MEMORANDUM

SUBJECT: Multifamily Objective Design Standards (MODS)

Revised Hearing Draft | June 2023

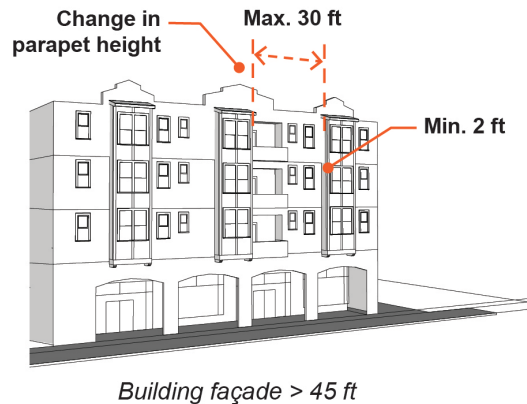
Part B.1.a.ii. change 25 façade bay to 30 feet façade bay which is typical of structural bay in multifamily development. Suggest that they match.

Page 7, top of page Roof line changes of 8 feet are a full story. Is that necessary? The illustration below shows roughly a change of 2 feet in height can provide the change, which is more typical.

3. B1a.ii. Eliminate requirement that building facades longer than 45 feet incorporate a change in roof parapet, form, or building height (p. 7)
4. B1b. Eliminate requirement that balconies and porches be integrated into recesses or overhangs on at least one side of the porch or balcony. (p. 7)
